Subject: Los Alamos National Laboratory's: (1) Notification of Name and Address Changes Provided for in Consent Agreement for Compliance Orders 93-01, 93-02, 93-03, and 93-04, and (2) Proposal for Revisions to the Remedial Action Plan Attachment to the Consent Agreement

ATTACHMENT 1

**RATIONALE FOR PROPOSED CHANGES
MATRIX**

Figure 2. Construction Phase I-R

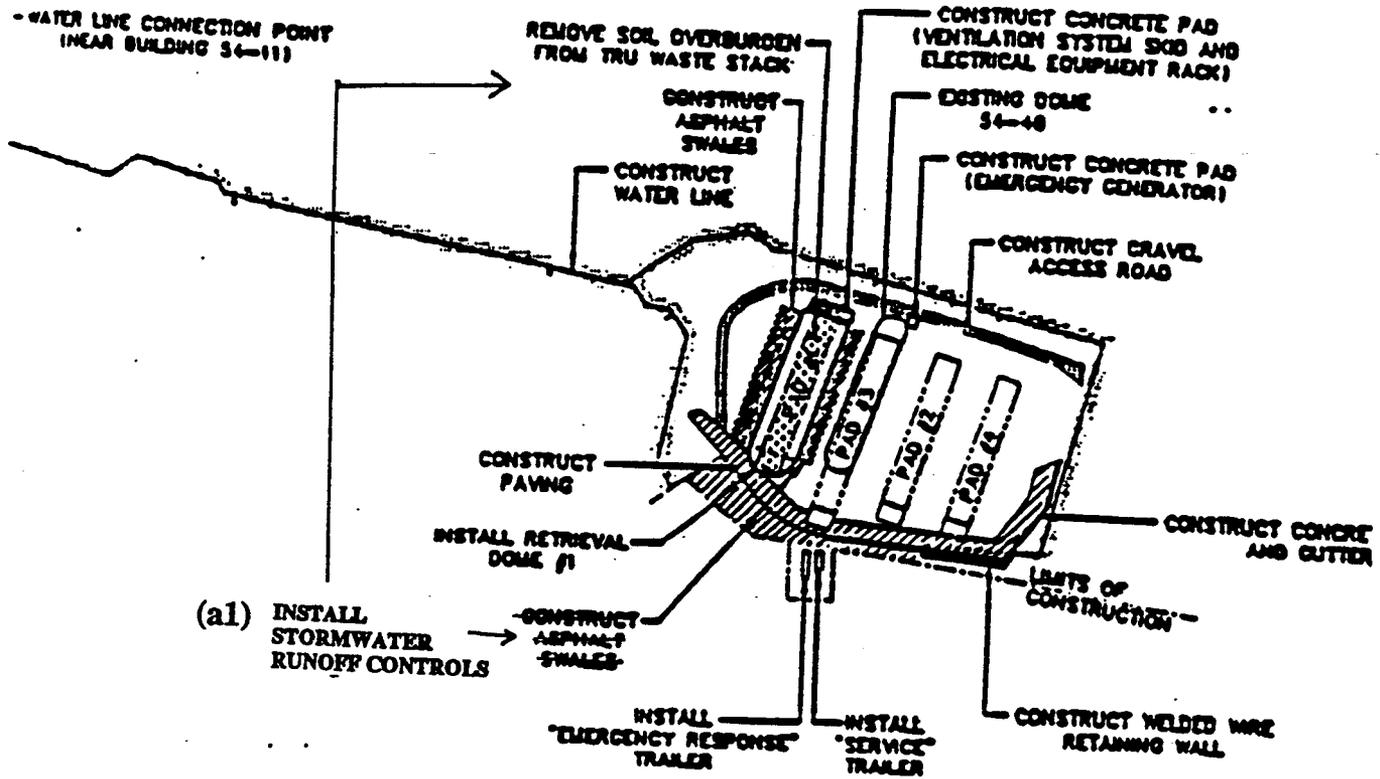
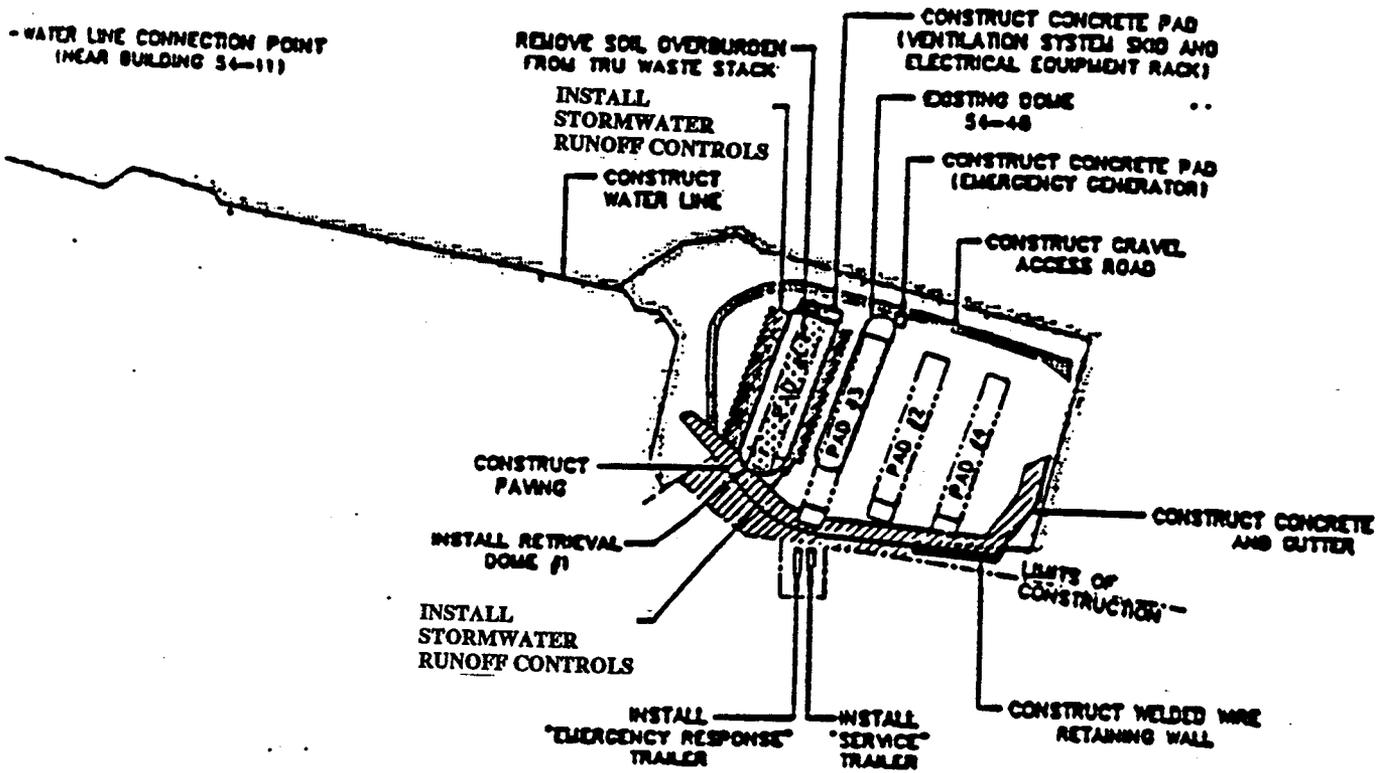
| Change no. | Pg. | Section | Para-graph | Description of Change | Rationale |
|------------|-----------|---------|--------------------|--|--|
| a1 | 4,6 and 8 | B.A | Figures 2, 4 and 6 | Change " <i>Asphalt Swales</i> " to " <i>Install Stormwater Runoff Controls</i> " | Various methods may be employed to control directional flow of stormwater which may include but not be limited to asphalt swales. See No. 2 below |
